Agenda Item	6.6
Report No	PLN/052/25

HIGHLAND COUNCIL

Report Title: 24/02439/FUL Barry Property Ltd

Former Bridgend Building Supplies Yard
Bridgend
Thurso

Topographical Survey of
Proposed Holiday Chalet
at Park Lane, Thurso
(Layout 1 of 2)

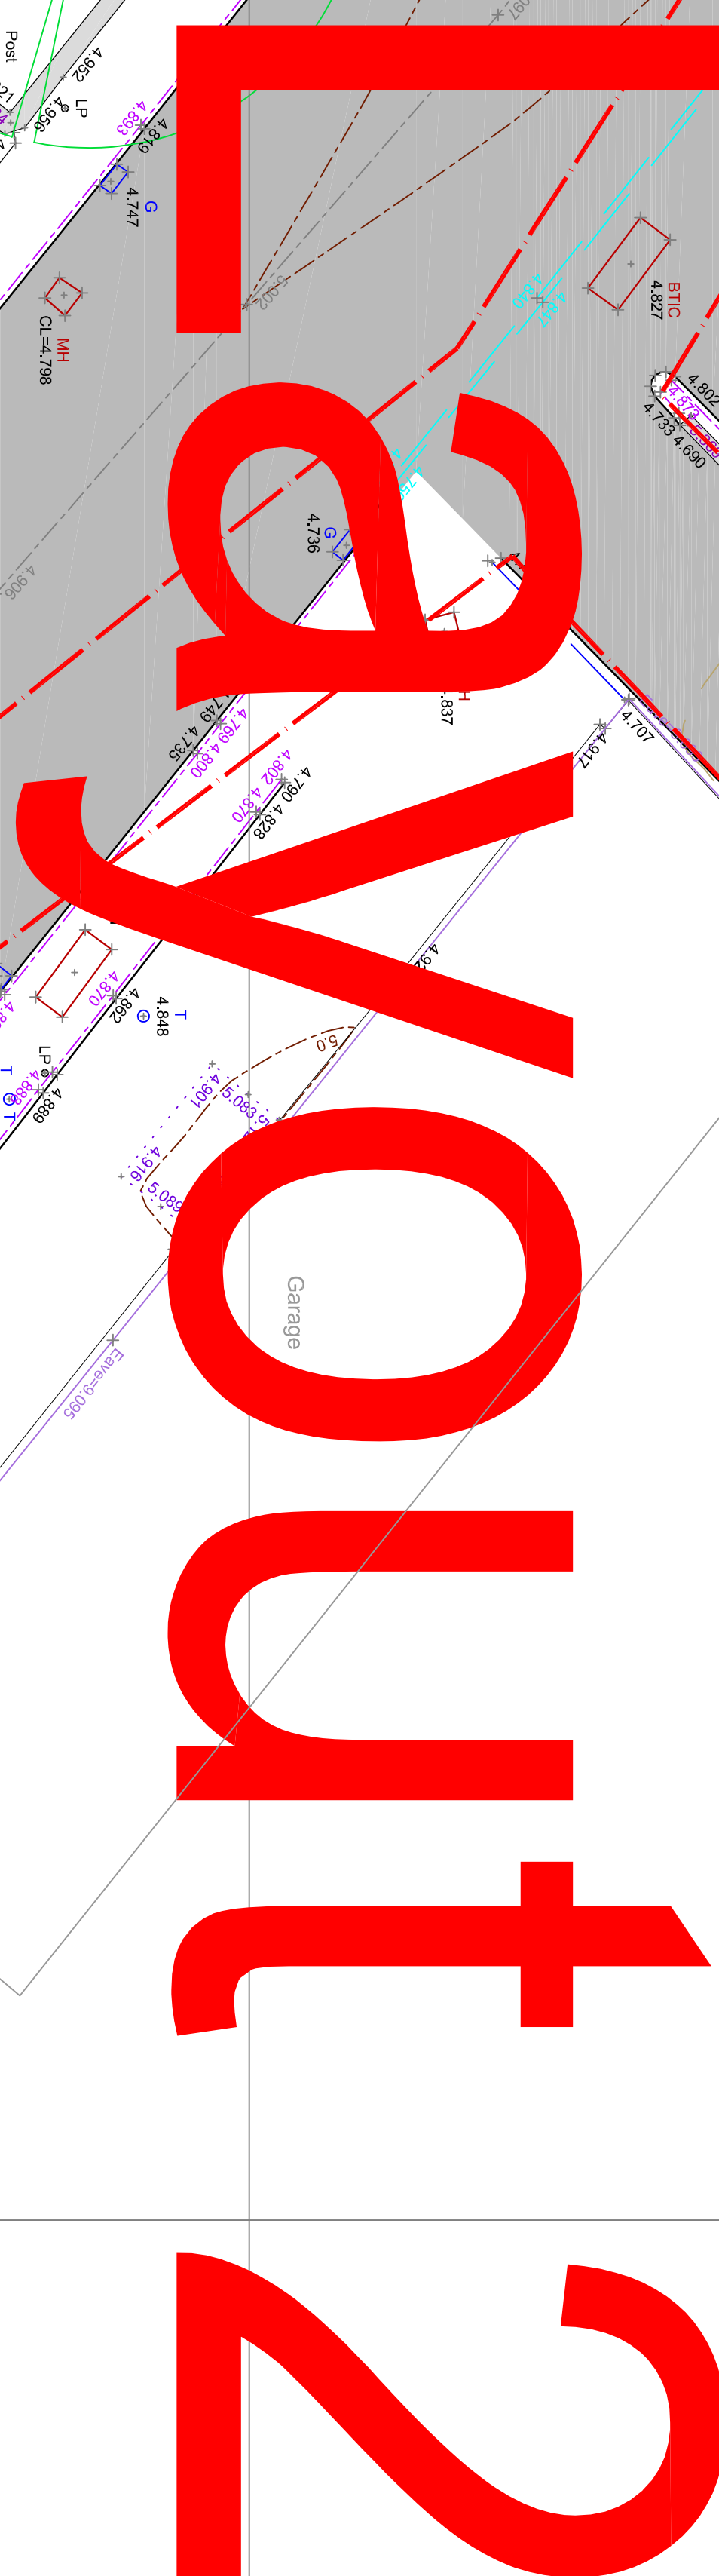
The topographic information provided (Drawing CTCH-J5586-001-00) shows that ground levels across the site are mostly below 4mAOD and, other than a small area of raised ground, maximum levels are around 4.6mAOD. This means that the flood depths of up to around 1m are expected across the site in the design flood event. This level is based on coastal still water levels alone and makes no account of any increased risk due to the impact of the River Thurso. The SEPA Flood Maps also do not account for the joint probability of coastal and fluvial interactions.

Proposed Visibility Splay
Scale: 1:500

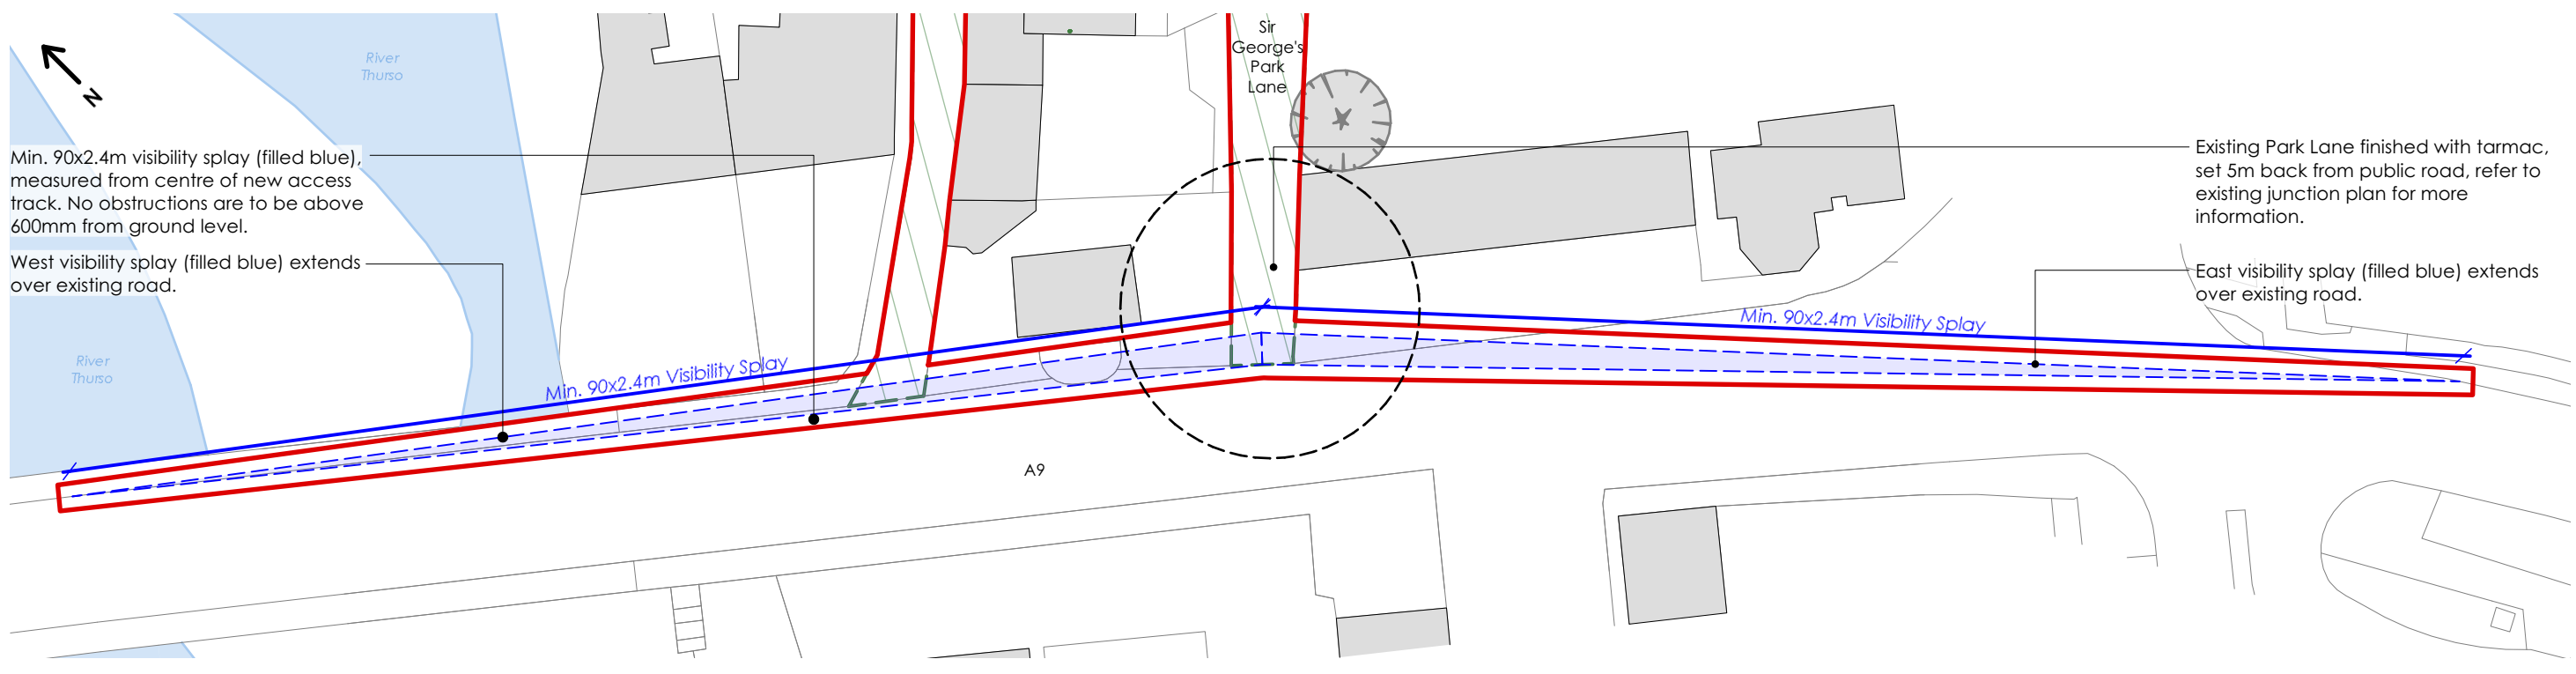
- 8.20 To address access constraints, a one-way system is proposed, using two existing access points. Egress would be taken via St George's Park Lane. A submitted visibility splay plan contended that visibility in either direction to 90 metres as required is demonstrated; this is considered to be realistic.
